**SUNDRY NOTICES AND REPORTS ON WELLS**  
*Do not use this form for proposals to drill or to re-enter an abandoned well. Use Form 3160-3 (APD) for such proposals.*

2. Name of Operator  
Vanguard Operating, LLC

8. Well Name and No.  
Doris Federal #2

9. API Well No.  
30-005-61003

AFTER P&A

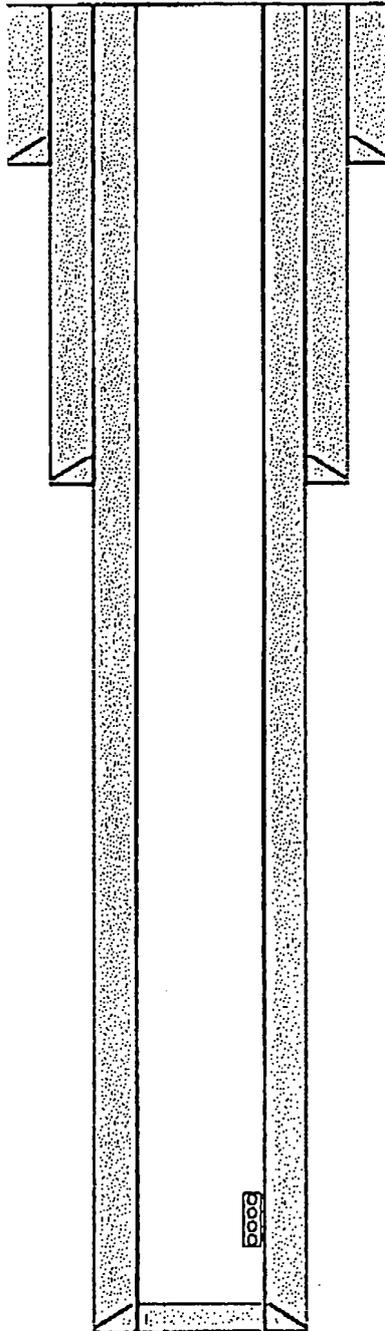
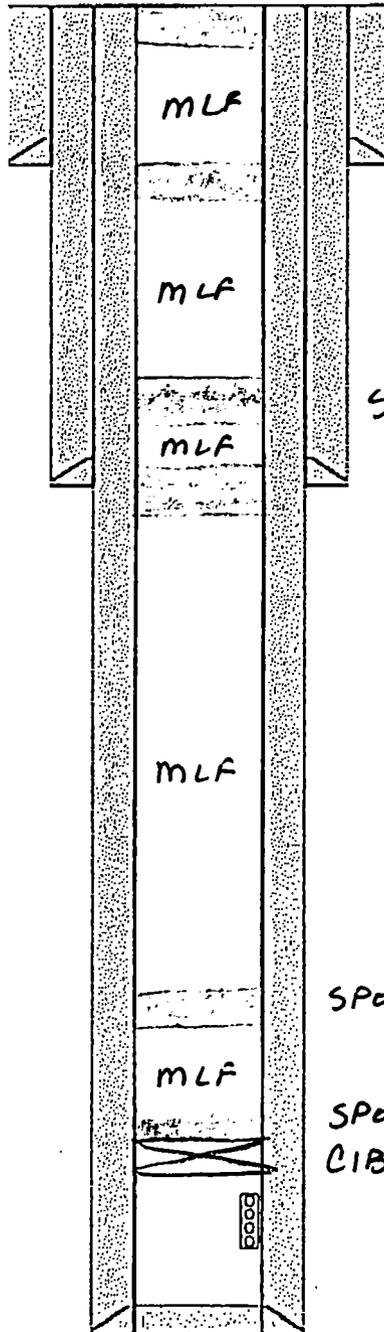
1. Notify BLM 24 hrs prior to MIRU to P&A.
2. Set CIBP @ 3628' RIH w/tbg & tag CIBP circ hole w/MLF test csg spot <sup>25</sup> 20 sx's cmt 3628'-3528' WOC & tag if csg don't test.
3. Spot 20 sx's cmt 2920'-2820' (Tubb) spot 20 sx's cmt 1758'-1658' (8 5/8" Shoe, Yeso) WOC & tag.
4. Spot 20 sx's cmt 1433'-1333' (Glorieta) spot 25 sx's cmt 790'-680' (13 3/8" Shoe, San Andres) WOC & tag spot 20 sx's cmt 100'-surf.
5. RD P&A equip, digout cut wellhead, install dry hole marker, clean location, move off.

1. Operator shall place CIBP 50'-100' above top most perf and place 25 sx of Class C cement on top to seal the Abo Formation. WOC and TAG.
2. Operator shall place a Class C cement plug from 2,920'-2,820' as proposed. WOC and TAG.
3. Operator shall place a Class C cement plug from 1,758'-1,658' as proposed to seal the 8-5/8" shoe. WOC and TAG.
4. Operator shall place a Class C cement plug from 1,500'-1,333' as proposed to seal the Glorietta Formation. WOC and TAG.
5. Operator shall place a Class C cement plug from 790'-680' as proposed to seal the 13-3/8" shoe. WOC and TAG.
6. Operator shall place a Class C cement plug from 100' to surface as proposed.
7. See Attached for general plugging stipulations.
